Revised ground floor plan

Original architecture: Fraser & Partners. New HAAVN concept study of the window changes. Furniture indicative; footprint and principal room dimensions retained.

High-window elevations and setting-out

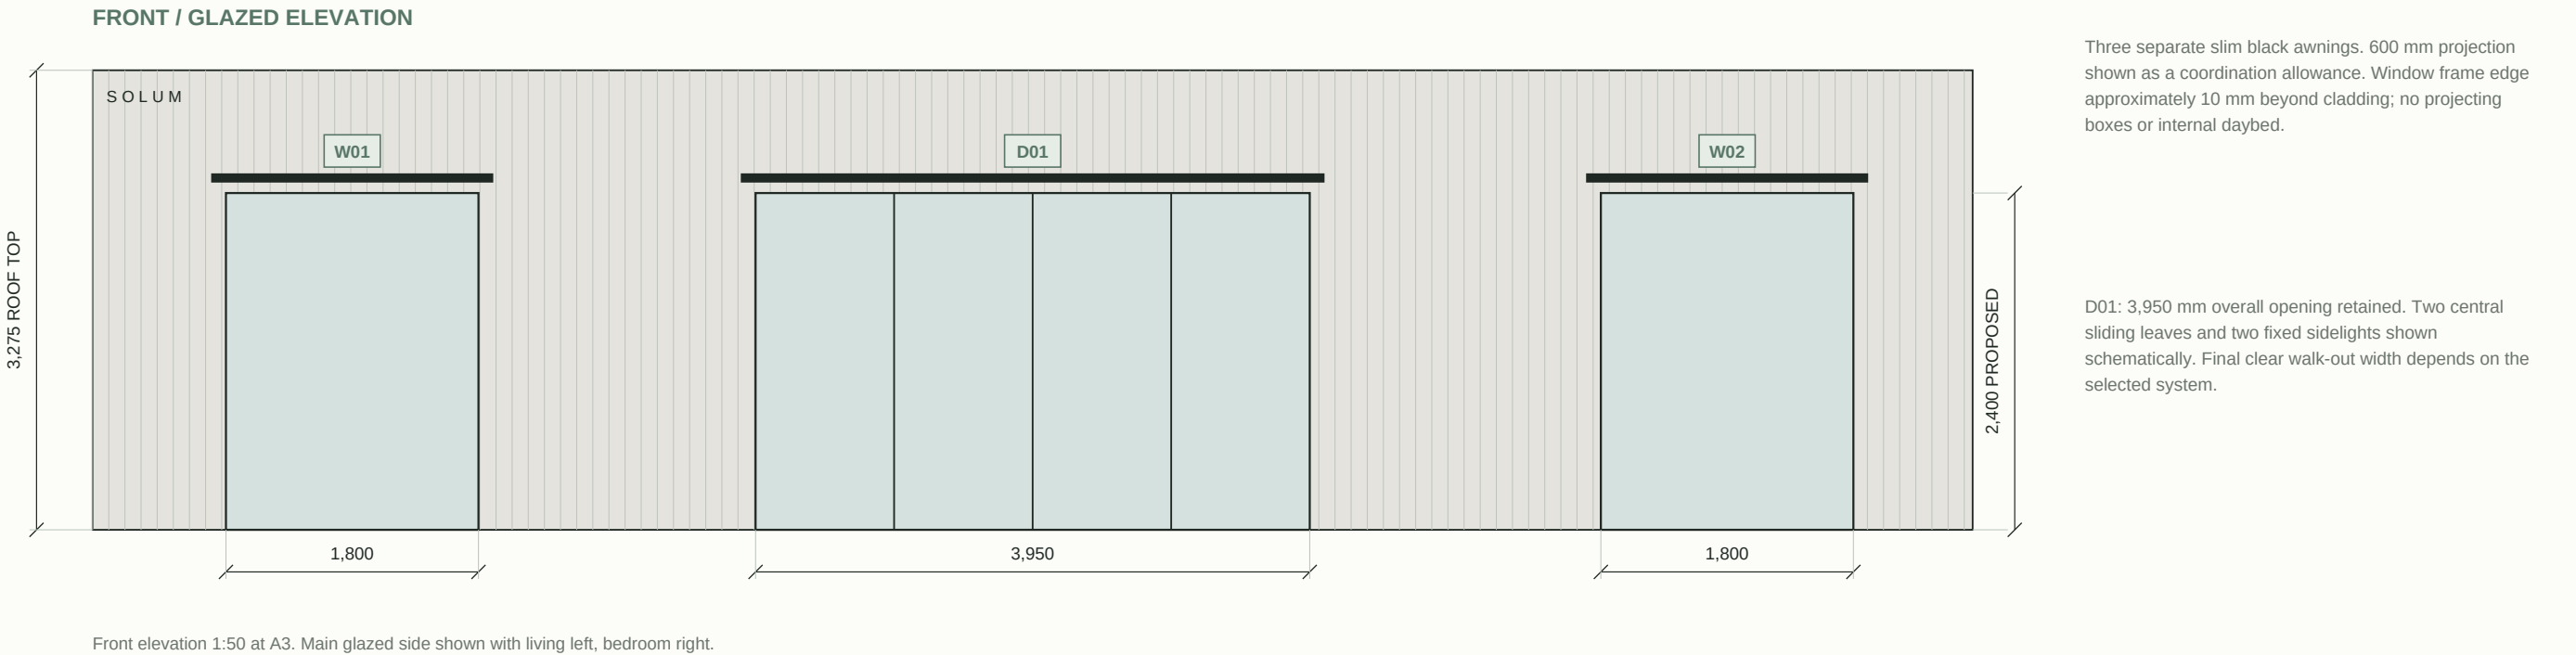
W01 / W02: 1,800 mm is a proposed design size to reproduce the approved narrow-window appearance. The previous render was not dimensioned, so its requested 500 mm reduction cannot be independently measured. The original GA side openings were 3,425 mm.

REAR / SHOWER ELEVATION

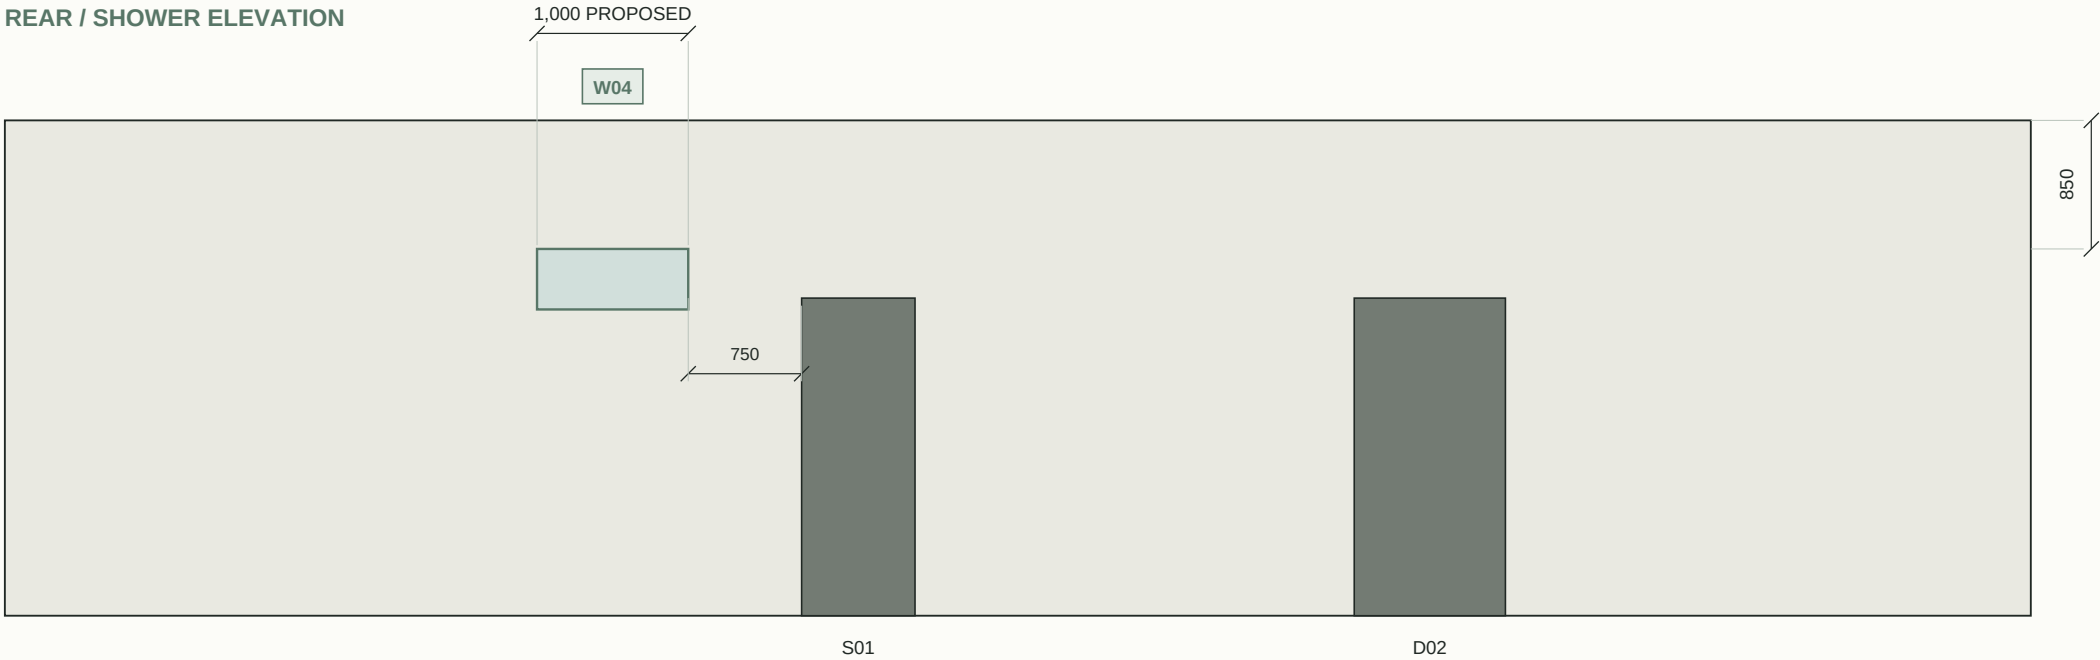
Rear entry and service access retained. No new window on the living end wall.

The red marks specify offsets, not final opening sizes. W03 and W04 widths and heights remain proposed. W03 is set 950 mm from the front corner in the bedroom end elevation. W04 is set 750 mm clear of the adjacent service opening. Final jamb clearances, framing and window operation require architect coordination.

BEDROOM END ELEVATION

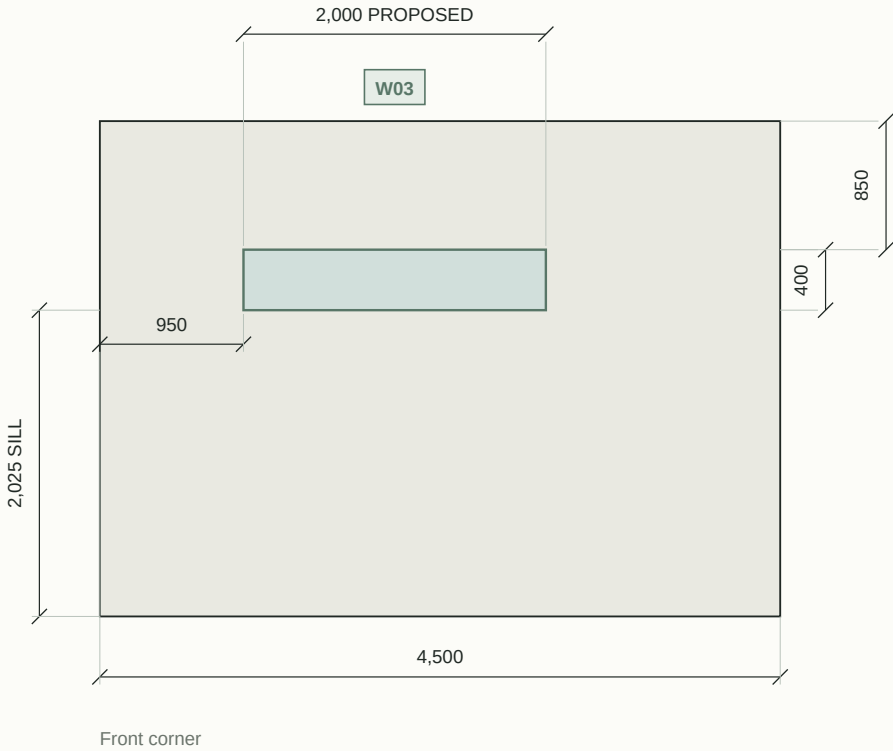
Marked roof-top-to-window-head distance: 850 mm.

Calculated high-window head above FFL: $3,050 + 350 - 125 - 850 = 2,425$ mm.

Proposed opening height: 400 mm. Sill above FFL: $2,425 - 400 = 2,025$ mm.
